## 3000 Series Zeus Pods Product Improvements

NOTICE		
Revised May 2014. This bulletin supersedes the previous bulletin number 2012-65R1 dated July 2012.		
Model	Product Improvement	Serial Range of Affected Units
Zeus JH Pods	Hydraulic Hose Inspection/Replacement	0M963373–0M966652
Zeus JH Pods	Hydraulic Pressure Transducer Replacement	0M963945–0M967171
Zeus JH Pods*	Electronic Module Reflash	0M963373–0M968241

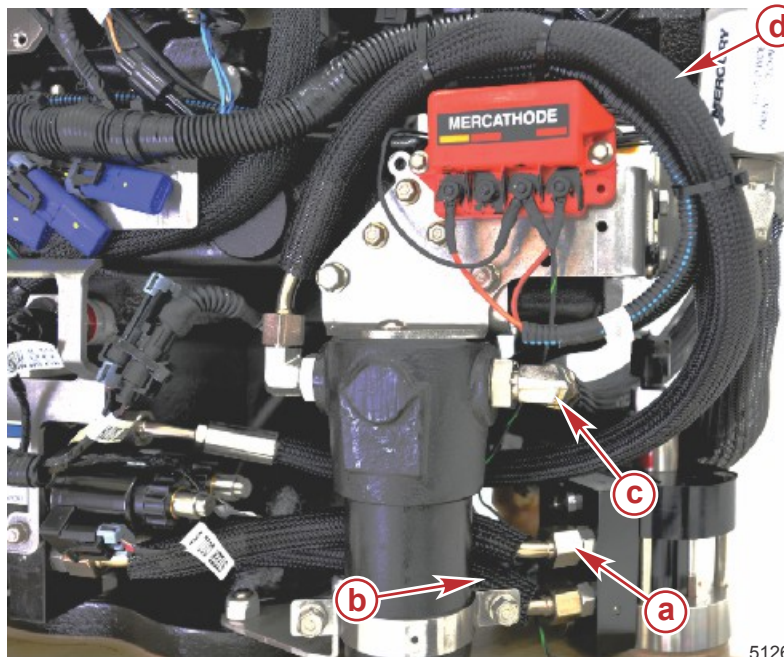
Inspect both ends of each hydraulic hose around the crimp area shown by the arrow in the illustration below for oil accumulation indicating a leak or weepage. In addition, check the hose rubber for saturation with oil that could also indicate weepage or a slow oil leak. If any of the four high-pressure hydraulic steering or trim tab hoses show signs of oil leakage, replace all four hoses on that pod and the four hoses on each additional pod on that boat. If no hoses on the pod being inspected are leaking, continue with inspection for each additional pod. If any of those hoses are found to be leaking, replace all hoses on each pod on that boat.

Use the following chart for the part numbers of each hose. Replace all four high-pressure steering and trim tab hoses if any pod is found to have leaking hoses, along with the hoses on all pods on the vessel.

51264

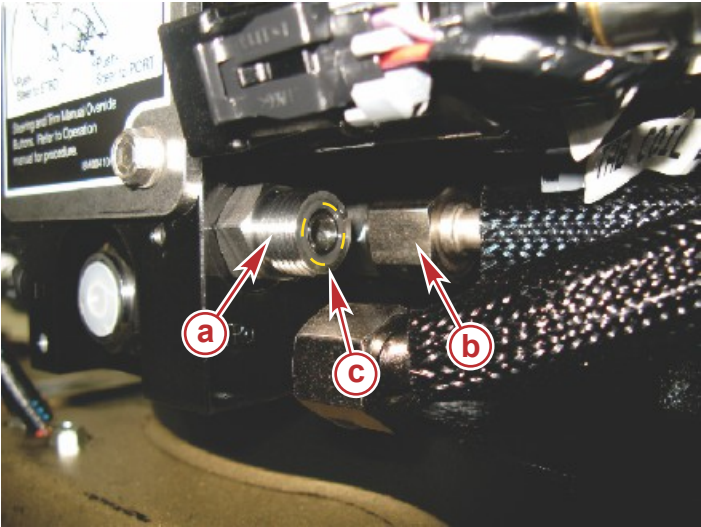
- a - Port A on steering manifold
- b - Port B on steering manifold
- c - Verify o-ring remains intact in fitting before installation of new hose

41885

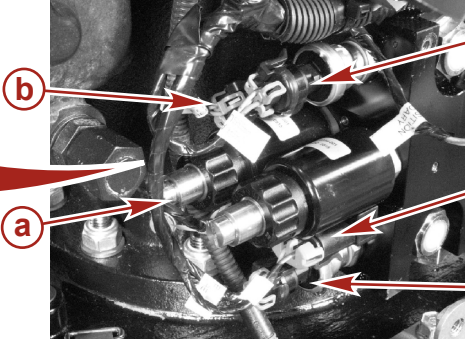
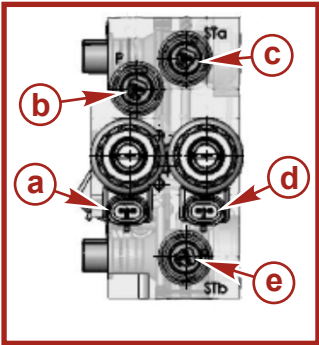
Each pod's hydraulic steering manifold contains three (3) pressure transducers. These steering pressure transducers are indicated by letters b, c, and e in the following illustration.

If the inspection reveals that the pressure transducers have already been changed to the new sensor shown in Figure B above, it is not necessary to replace them. If the inspection reveals the pressure transducers for the steering and trim tab systems have not been replaced and are identified as the transducer shown in Figure A above, replace each of the transducers on each pod. JH Zeus applications will need five total transducers for steering and trim tab hydraulic systems.

42111

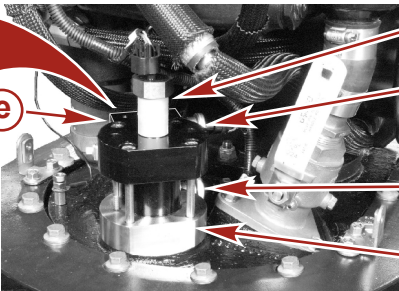
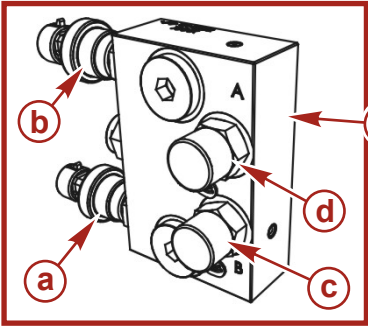
Each pod's hydraulic trim tab manifold contains two (2) pressure transducers. These trim tab pressure transducers are identified by the letters a and b in the following illustration.
